# Value Engineering Study Report

*Project No. BRSTO-0998-00(001)*

*SR 324 Gravel Springs Road @ I-85*

*Gwinnett County*

ALTERNATIVE NO.:  
**BR-3**

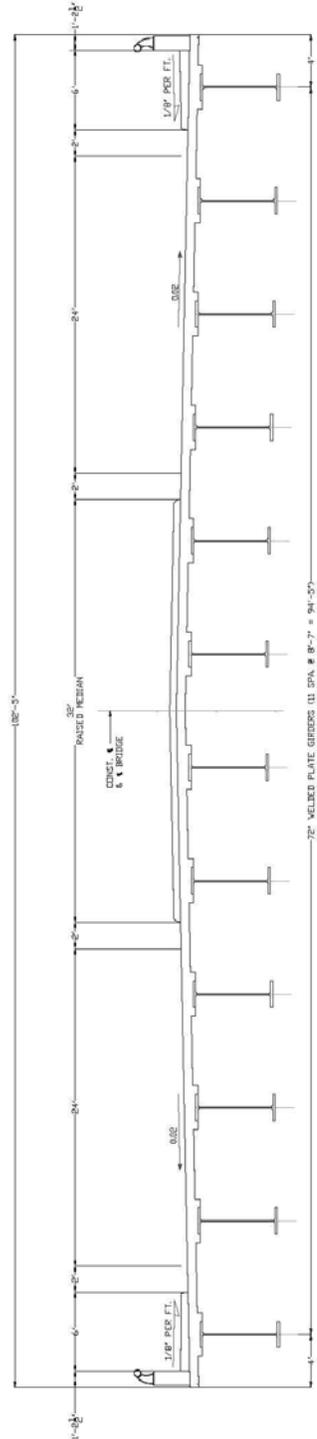
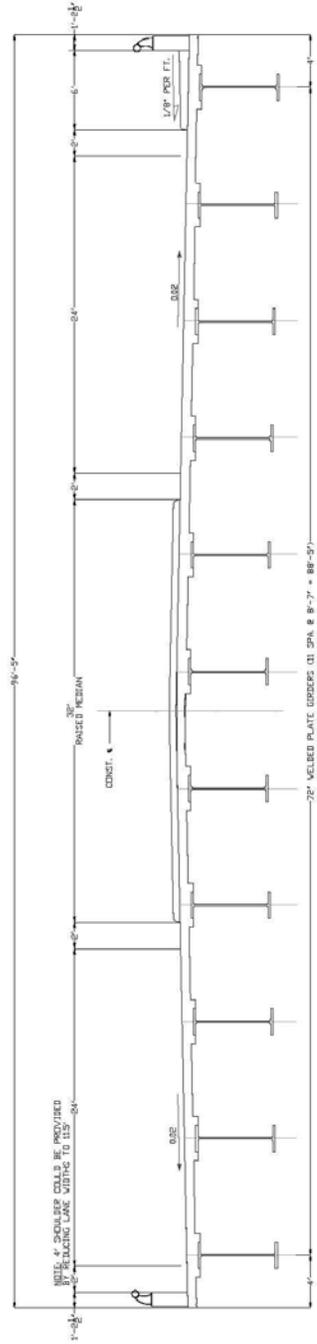
The original design calls for a skewed, 466' long, 3 span bridge with MSE walled abutments. The end spans are 146.5' and the intermediate span is 173.0' long. From final bridge plans made available to the VE Team, it appears that the superstructure comprises of a concrete deck on steel plate girders, approximately 75" deep, made continuous over the 3 spans. The bridge crosses the future (conceptual) widened sections of I-85. The out-to-out width of the bridge is 102'-5" to accommodate 6' raised sidewalks on each side, a 32' median (6' raised) and two 12' travel lanes in each direction. It is proposed that the raised median be removed in future to accommodate two turn lanes when this crossing is converted to a TUD Interchange. The intermediate bents are made up of concrete caps and columns and founded on pile caps supported by Steel H Piles.

A more detailed cost analysis may be performed on sufficiently developed alternative bridge plans to be able to itemize major components and realize greater cost savings than that shown in this study. Example: One girder line can be eliminated, concrete grooving reduced, etc.

ALTERNATIVE NO.:  
**BR-4**

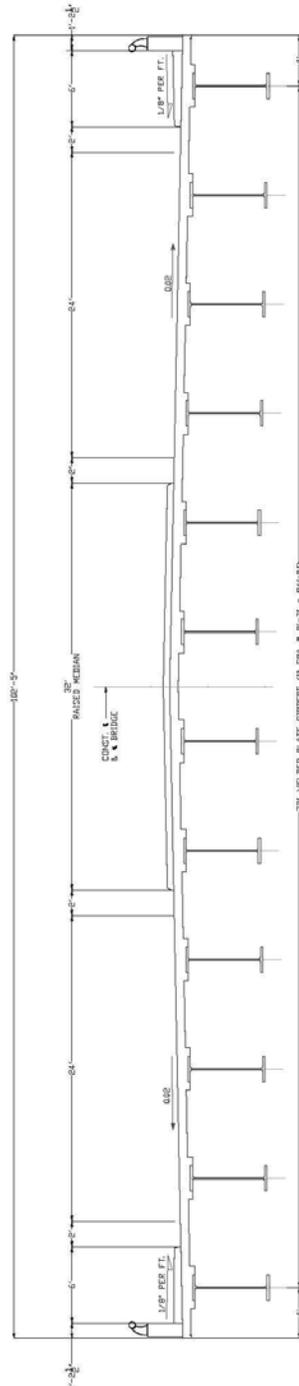
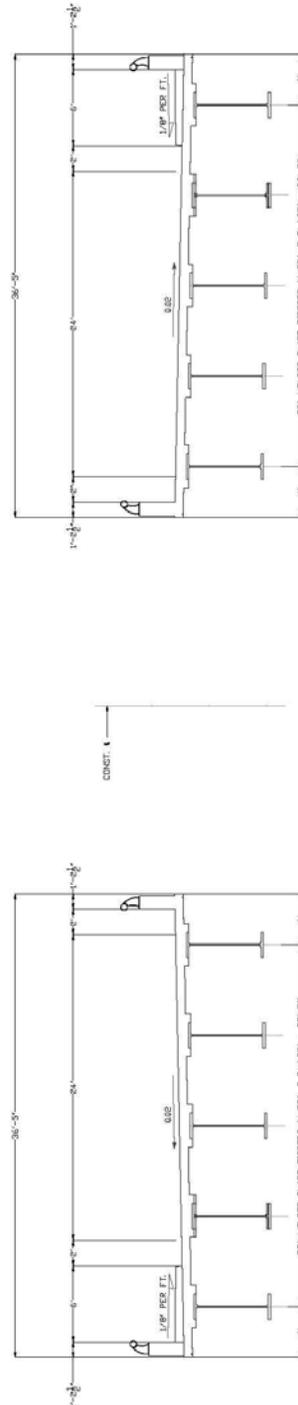
The original design calls for a skewed, 466' long, 3 span bridge with MSE walled abutments. The end spans are 146.5' and the intermediate span is 173.0' long. From final bridge plans made available to the VE Team, it appears that the superstructure comprises of a concrete deck on steel plate girders, approximately 75" deep, made continuous over the 3 spans. The bridge crosses the future (conceptual) widened sections of I-85. The out-to-out width of the bridge is 102'-5" to accommodate 6' raised sidewalks on each side, a 32' median (6' raised) and two 12' travel lanes in each direction. It is proposed that the raised median be removed in future to accommodate two turn lanes when this crossing is converted to a TUD Interchange. The intermediate bents are made up of concrete caps and columns and founded on pile caps supported by Steel H Piles.

ALTERNATIVE NO.:  
**BR-6**

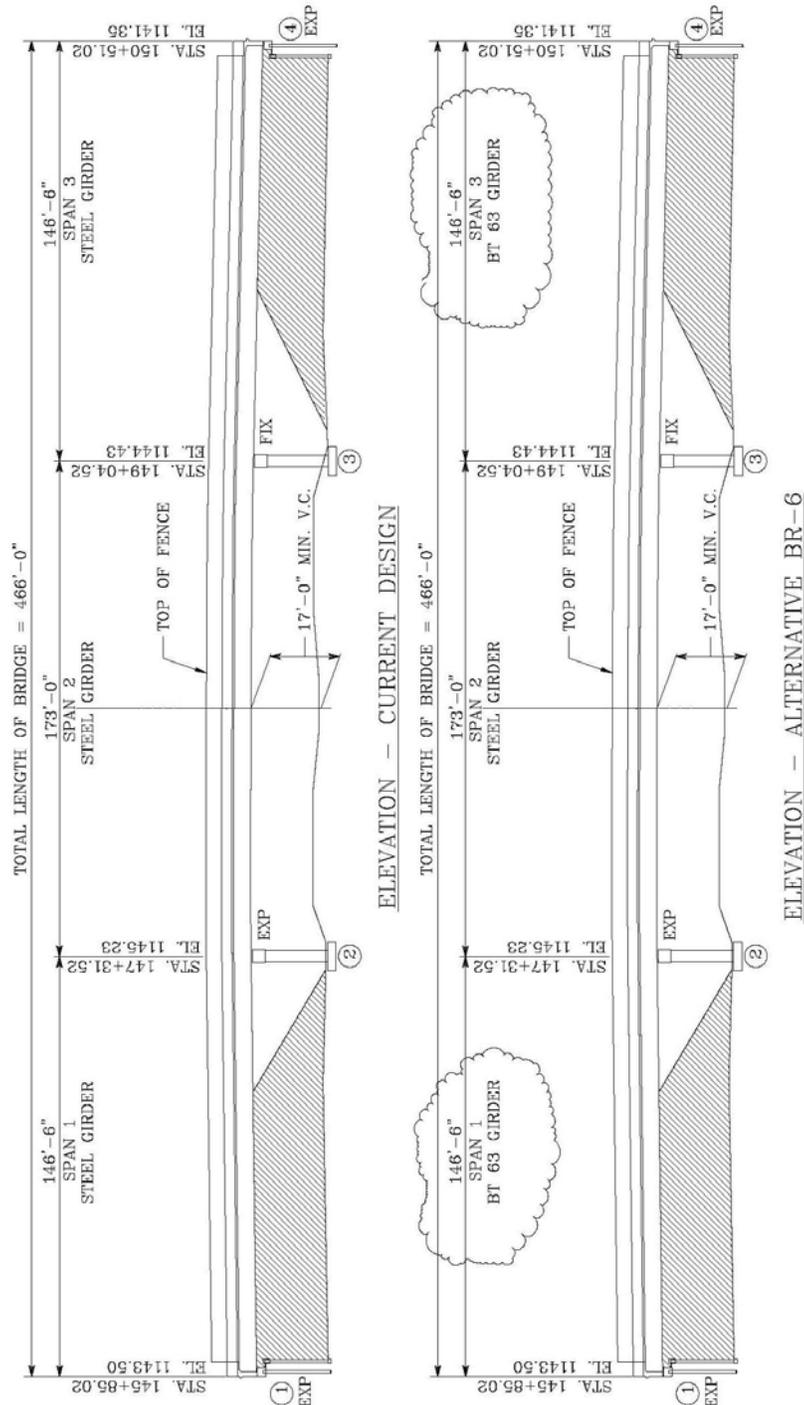
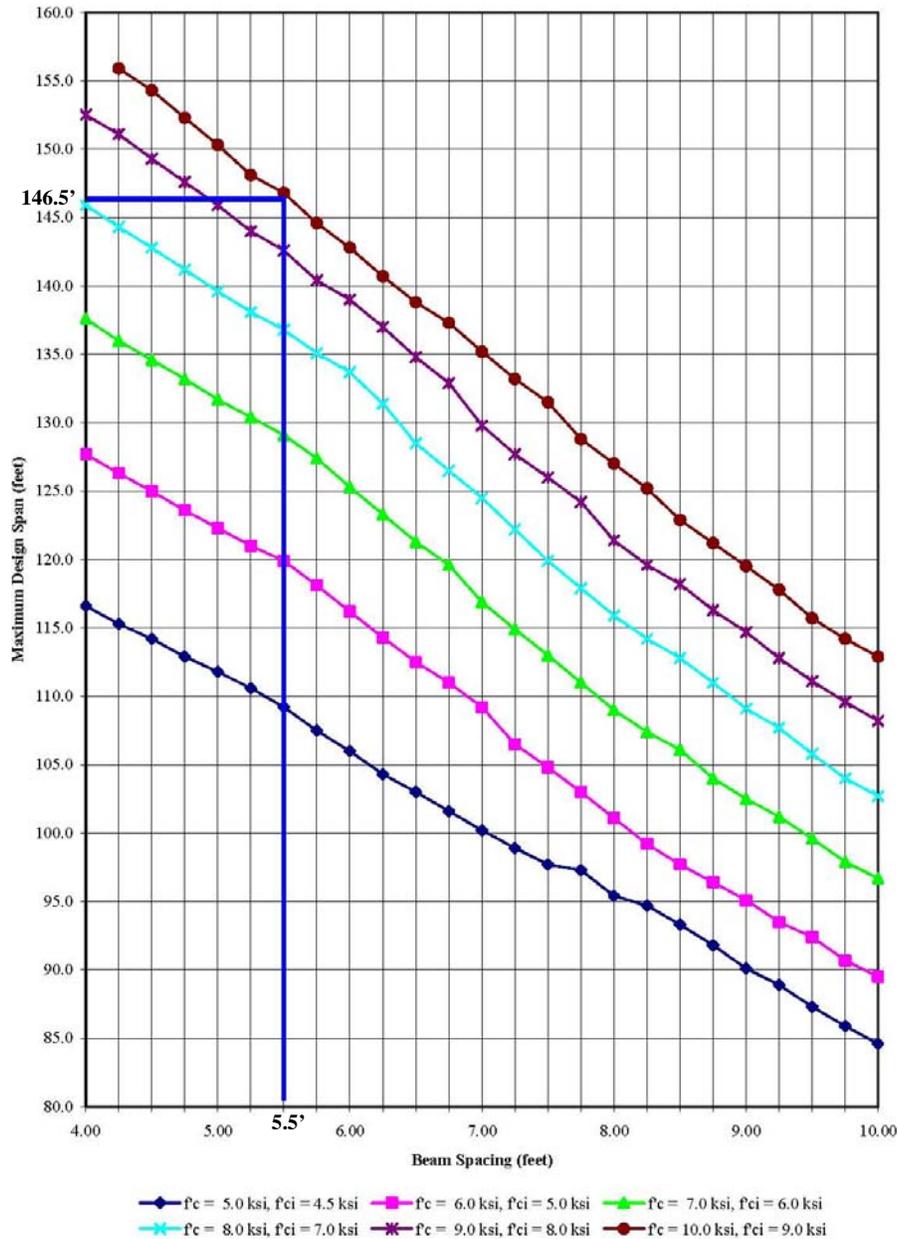
PROJECT:	<b>Georgia Department of Transportation BRST0-0998-00(001) – P.I. No.: 142285 SR 324 Gravel Springs Rd. @ I-85 Gwinnett County</b>	ALTERNATIVE NO.:	<b>BR-6</b>
DESCRIPTION:	<b>Use BT 63 girders on end spans in-lieu of steel girders</b>	SHEET NO.:	<b>1 of 5</b>

The original design calls for a skewed, 466' long, 3 span bridge with MSE walled abutments. The end spans are 146.5' and the intermediate span is 173.0' long. From final bridge plans made available to the VE Team, it appears that the superstructure comprises of a concrete deck on steel plate girders, approximately 75" deep, made continuous over the 3 spans. The bridge crosses the future (conceptual) widened sections of I-85. The out-to-out width of the bridge is 102'-5" to accommodate 6' raised sidewalks on each side, a 32' median (6' raised) and two 12' travel lanes in each direction. It is proposed that the raised median be removed in the future to accommodate two turn lanes when this crossing is converted to a TUD Interchange. The intermediate bents are made up of concrete caps and columns and founded on pile caps supported by Steel H Piles.
